RE: Docket 0002, Comments on the May 15, 2003 Concept for CBRN (Chemical Biological Radiological Nuclear) Escape Respirator Standard

3M Comments on the May 15, 2003 Draft Concept for CBRN Air-Purifying Escape Respirator

Table 1. Required Carbon volumes for 1300 ppm and 2600 ppm Cyclohexane Challenges

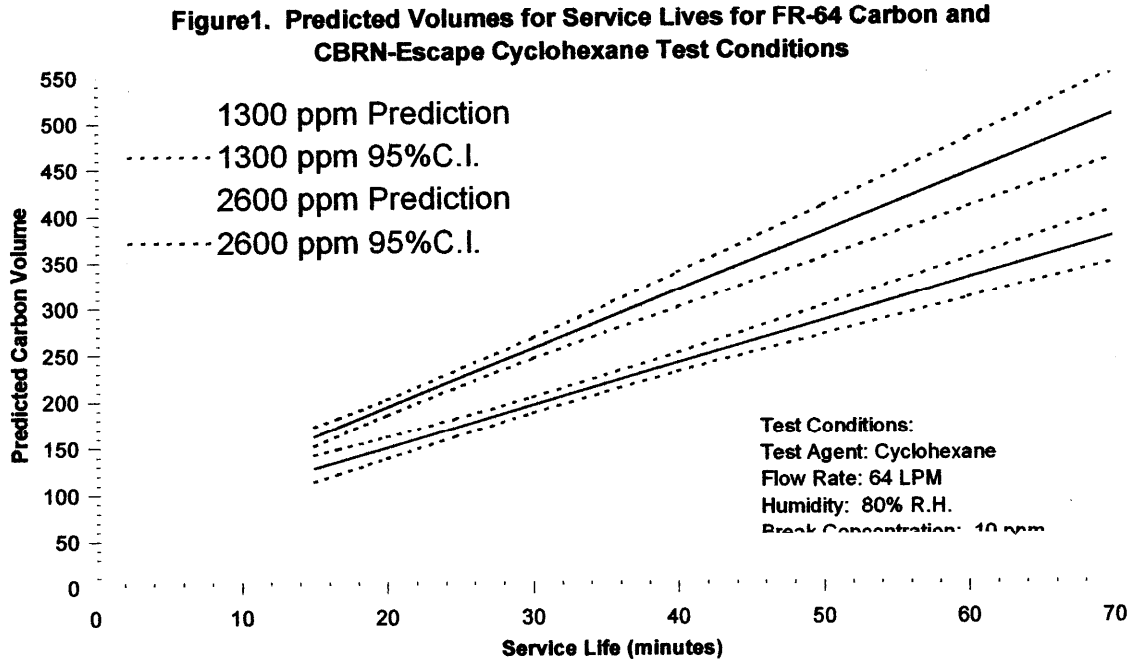
The test concentrations for cyclohexane and cyanogen chloride doubled in the May 15th version of the Concept. Justification for the 1300 ppm cyclohexane and 150 ppm cyanogen chloride was given at the April 29th meeting. We recommend that the levels stay as presented at the April 29th meeting.

The doubling of the organic vapor requirement – to the level of the October 15 draft - takes us back to the requirement for a larger filter, which is not as acceptable to users based on our research. Cyclohexane is a critical test agent in determining carbon volume. We have conducted a number of experiments that shows the necessary carbon volume needed to pass a variety of cyclohexane challenge concentrations and times. Figure 1 predicts the volumes for service lives for a 3M carbon that is utilized in one of our products. It illustrates that at a 15-minute, 1300 ppm challenge/10 ppm breakthrough an approximate carbon volume of 127 cc is needed, compared to 162 cc with a 2600-ppm challenge with all other conditions the same. Table 1 outlines the predictive relationships between carbon volumes and a 1300-ppm and 2600 ppm challenge.

Raising the challenge to 2600 ppm will require larger filter housings than current products use. As noted above, however, these larger products are undesirable by the majority of end users. We understand that some users may require a higher volume of carbon capacity for their expected hazard. Devices with a higher volume can be selected by choosing one having a longer duration rating. We suggest that by having

a 1300 ppm challenge at four duration ratings of 15, 30, 46 and 60 minutes, end users will have the capability of using products with carbon volumes ranging from approximately 125cc to 330 cc. This recommendation permits current technology to be used in an acceptable cartridge size.
